**Tillbridge Solar Project
EN010142**

**Volume 9
Statement of Common Ground with Trent Valley
Internal Drainage Board
Document Reference: EN010142/APP/9.14**

**April 2025
Revision Number: 010**

Figure 1: Trent Valley Internal Drainage Board Crossings

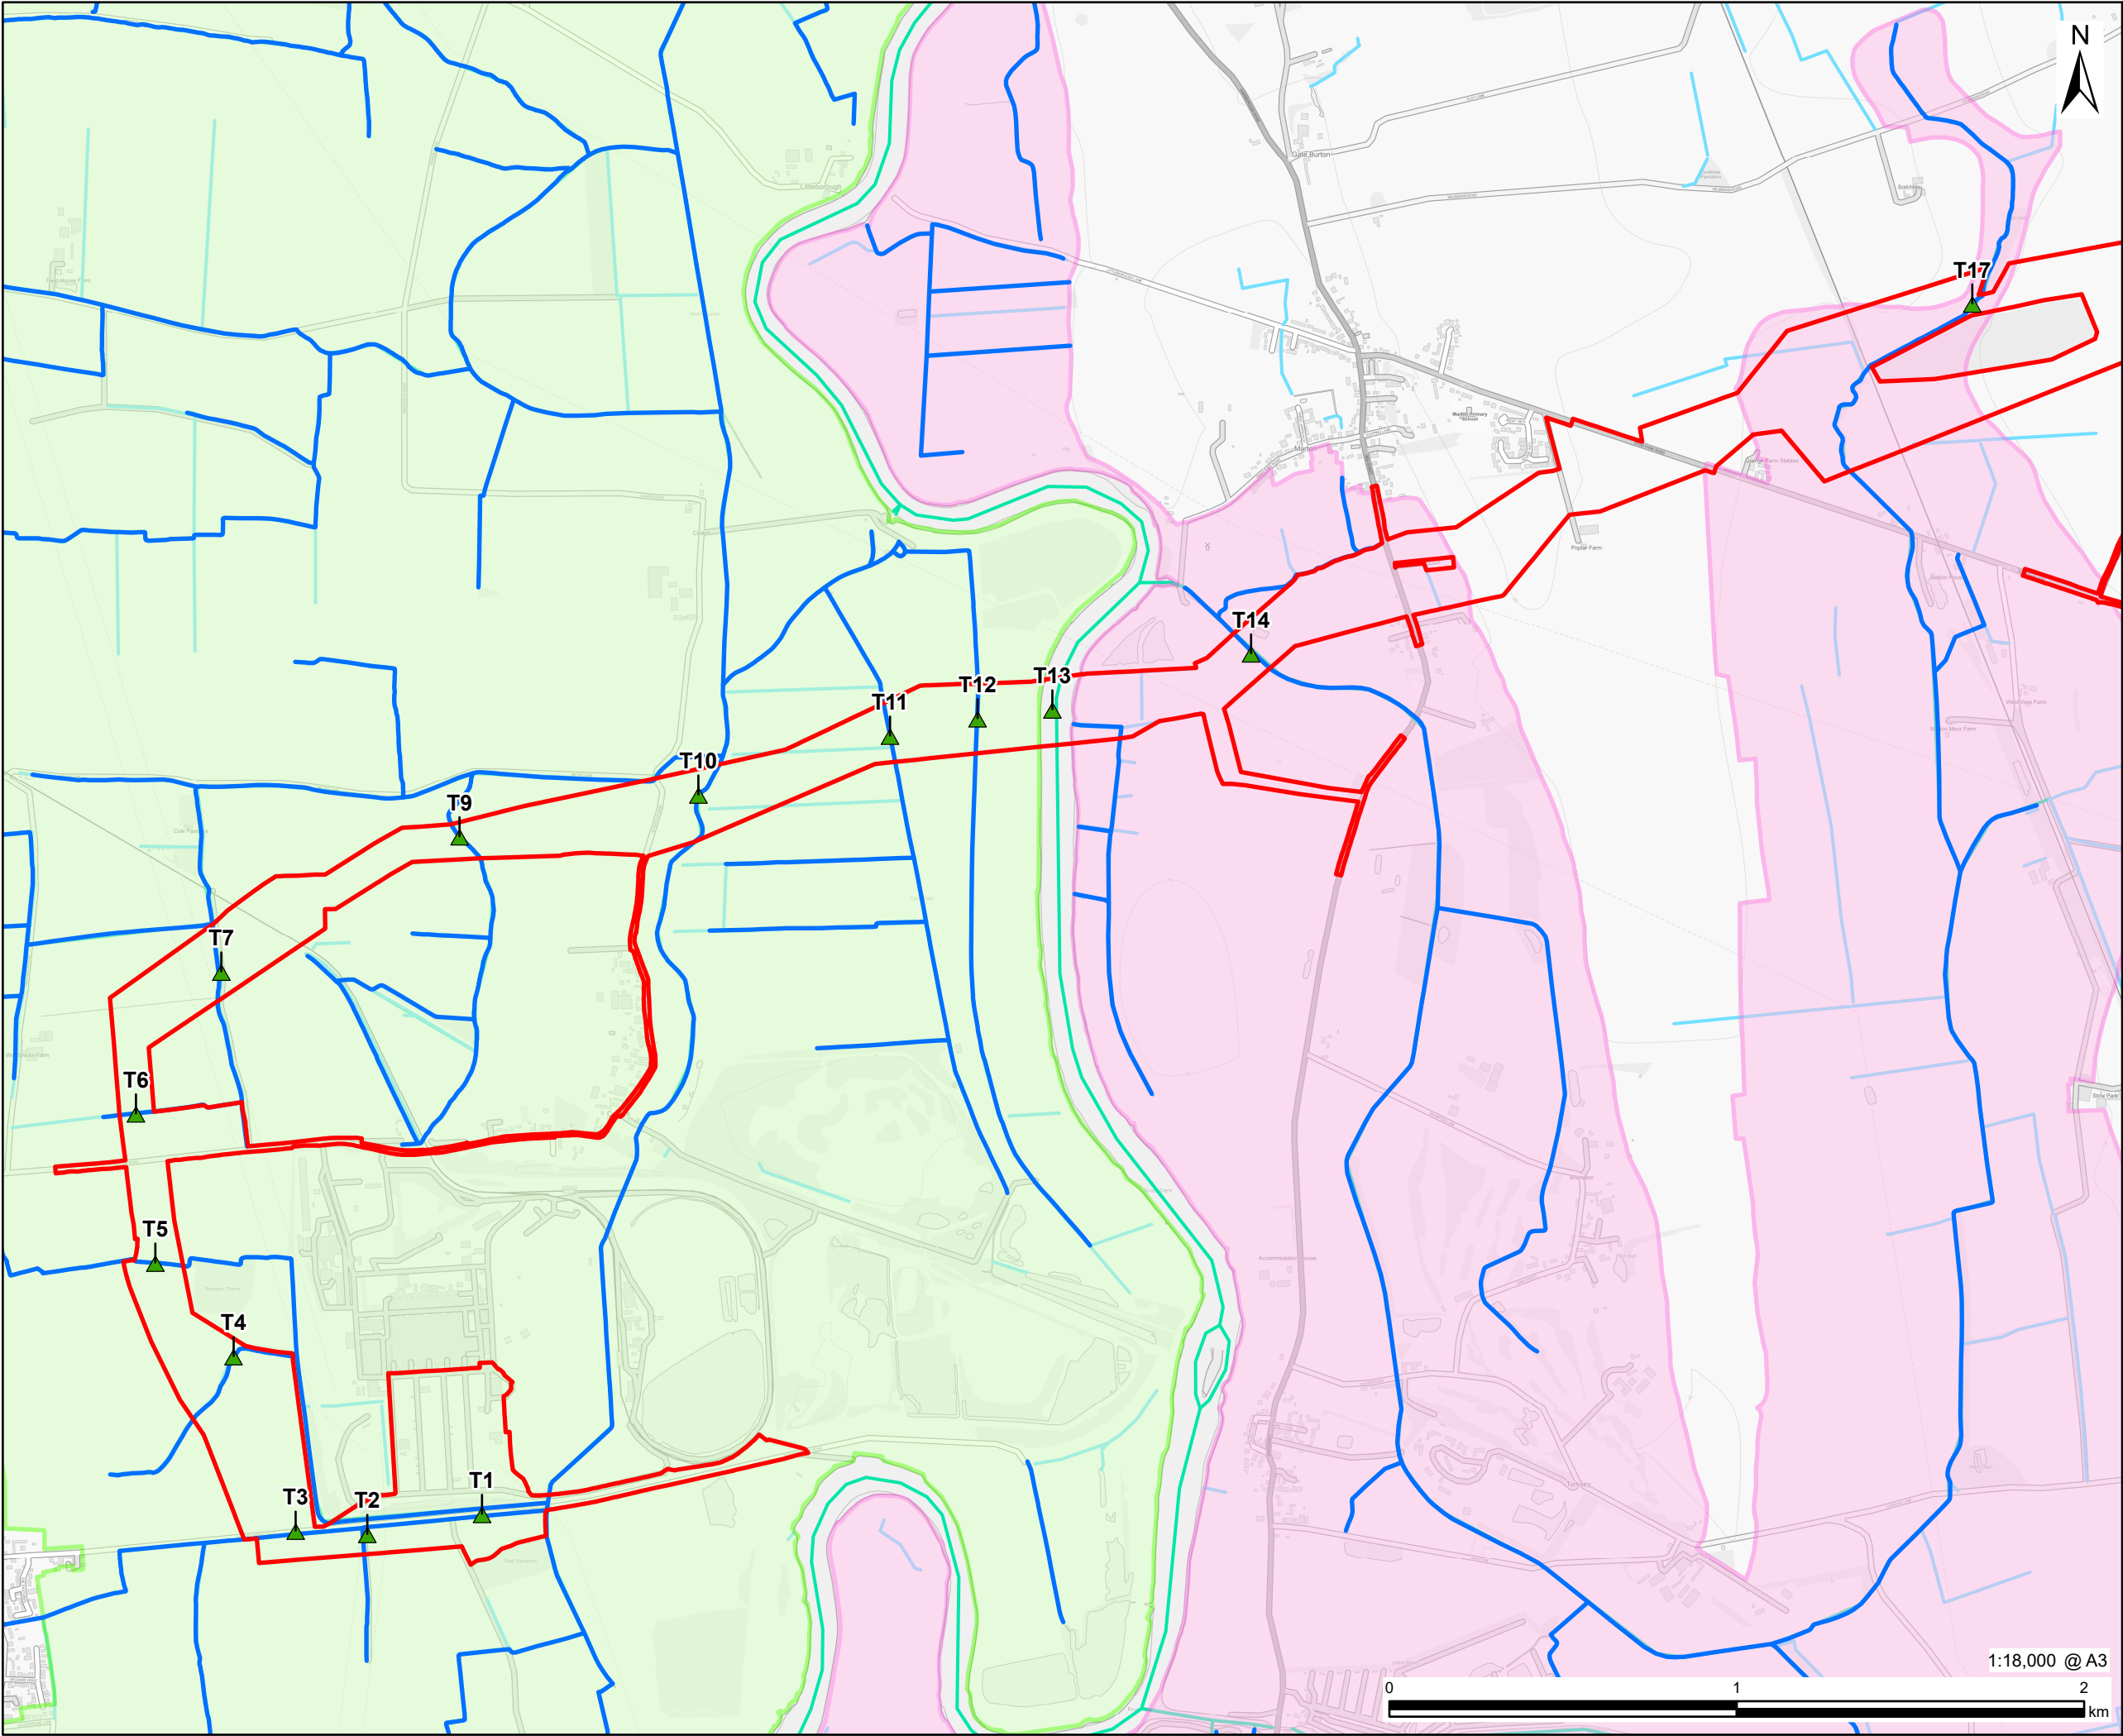
Ref. Relevant Application Document	Description of Matter	Status	Likelihood of Resolution
	<p>This matter should be discussed further and in more detail as the proposed cable route is refined. Any culverting or other works within the bed of any riparian watercourse within the Board's district be they temporary or permanent will also require consent. The Board would not look to be disapplying section 23 of the Land Drainage Act 1991. It should be noted that the Board's consent is required irrespective of any permission gained under the Town and Country Planning Act 1990.</p> <p>The Board's consent will only be granted where proposals are not detrimental to the flow or stability of the watercourse/ culvert or the Board's machinery access to the watercourse/ culvert which is required for annual maintenance, periodic improvement and emergency works.</p> <p><u>Applicant's Response:</u></p> <p>There are no permanent above ground works proposed within the TVIDB administrative area. Consent for any discharges or temporary crossings during construction would be applied for prior to the works, as set out within the Framework CEMP [EN010142/APP/7.8 (Rev01)]. Compliance with the Framework CEMP [EN010142/APP/7.8 (Rev01)] is secured by the Requirements of the draft DCO [EN010142/APP/3.1(Rev03)].</p> <p>For permanent infrastructure, non-intrusive trenchless crossings are proposed along the TVIDB maintained watercourses, as presented on Figure 1 within Appendix A of this SoCG. Indicative coordinates for</p>

Ref. Relevant Application Document	Description of Matter	Status	Likelihood of Resolution																																																
	<p>the trenchless crossings within the TVIDB area are provided below. These will be confirmed following detailed design post-DCO consent, in accordance with the protected provisions set out within Schedule 15, Part 3 of the draft DCO [EN010142/APP/3.1(Rev03)].</p>

<p>As set out within the Outline Design Principles Statement [AS-058], the minimum depth of trenchless crossings below watercourses will be 3m and maximum depth will be 5m. This is with the exception of the River Till and the River Trent where cables will be installed at a</p>	Label	Northing	Easting	T1	378686	481456	T2	378629	481126	T3	378638	480920	T4	379140	480741	T5	379409	480515	T6	379839	480460	T7	380247	480706	T8	38035	480874	T9	380636	481391	T10	380757	482079	T11	380926	482631	T12	380976	482883	T13	381001	483098	T14	381163	483670	T17	382170	485747		
Label	Northing	Easting																																																	
T1	378686	481456																																																	
T2	378629	481126																																																	
T3	378638	480920																																																	
T4	379140	480741																																																	
T5	379409	480515																																																	
T6	379839	480460																																																	
T7	380247	480706																																																	
T8	38035	480874																																																	
T9	380636	481391																																																	
T10	380757	482079																																																	
T11	380926	482631																																																	
T12	380976	482883																																																	
T13	381001	483098																																																	
T14	381163	483670																																																	
T17	382170	485747

Ref.	Relevant Application Document	Description of Matter	Status	Likelihood of Resolution
		<p>minimum of 5m below the lowest surveyed point of the riverbed, and a maximum depth of 25m, depending on the ground investigation results. Compliance with the Outline Design Principles Statement [AS-058] is secured by the Requirements of the draft DCO [EN010142/APP/3.1(Rev03)].</p> <p>The project does seek to disapply section 23 of the Land Drainage Act, as well as byelaws made by TVIDB underneath section 66 of the Land Drainage Act 1991. However, approval rights would still be retained by TVIDB over works within 9m of watercourses (including crossings by cabling) within the draft protective provisions proposed within Schedule 15, Part 3 of the draft DCO [EN010142/APP/3.1(Rev03)].</p>		
Other Items
